Access Compliance Report

Public Rights-of-Way

(Curb Ramps)

Intersection ID: 12783	Main Street: E_5TH_ST	Cross Street: N_ALEXANDER_ST	Location: S
ADA ID: 50A6B0D16EAF	Ramp Type: PerpDiag	Initial Pass/Fail: Fail	Overall Compliance: No
Codes/Mitigation Info/Possible Solution		Field Measurements/Component Compliance	
Severity Score: 33.75

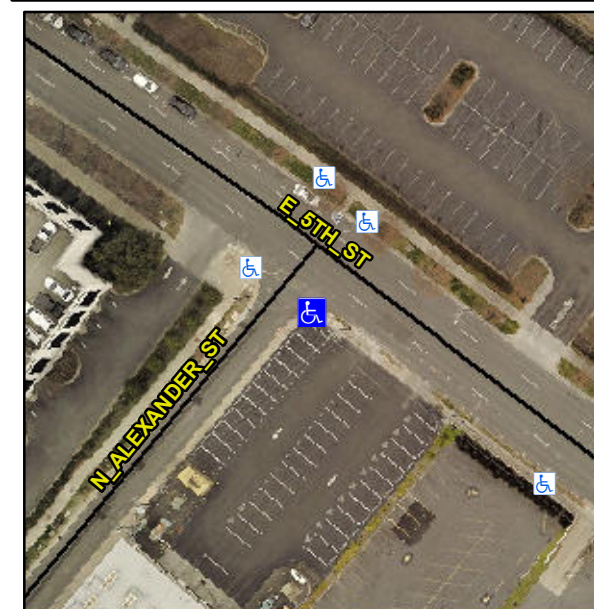
R304.5.1, R304.2.2

Compliance	Description	Data	Compliance	Description	Data
N/A	Ramp Length (in)	51.0	No	Ramp Slope (%)	16.3
No	Ramp Width (in)	45.0	Yes	Ramp XSlope (%)	1.3
N/A	Flare Type LT	N/A	N/A	Flare Type RT	N/A
N/A	Flare Slope LT (%)	N/A	N/A	Flare Slope RT (%)	N/A
N/A	Flare Traversable LT?	N/A	N/A	Flare Traversable RT?	N/A
N/A	Landing Length (in)	N/A	N/A	DWS Provided?	N/A
N/A	Landing Width (in)	N/A	N/A	DWS Contrast?	N/A
N/A	Landing Slope (%)	N/A	N/A	DWS Length (in)	N/A
N/A	Landing X Slope (%)	N/A	N/A	DWS Full Width?	N/A
N/A	Landing Curb? (Y/N)	N/A	N/A	DWS Offset (in)	N/A
N/A	Shared Landing?	N/A			
N/A	Gutter Ponding?	N/A	N/A	Gutter Slope (%)	N/A
N/A	Gutter Lip Ht (in)	N/A	N/A	Gutter X Slope (%)	N/A
N/A	Painted X Walk1?	No	N/A	Painted X Walk2?	No
	X Walk 1 Direction	To NE		X Walk 2 Direction	To NW
N/A	X Walk 1 Width (in)	N/A	N/A	X Walk 2 Width (in)	N/A
	X Walk 1 Slope (%)	2.9		X Walk 2 Slope (%)	0.5
	X Walk 1 X Slope (%)	0.1		X Walk 2 X Slope (%)	3.8

Remove & Replace Curb Ramp With Two New Directional Ramps or Equivalent.
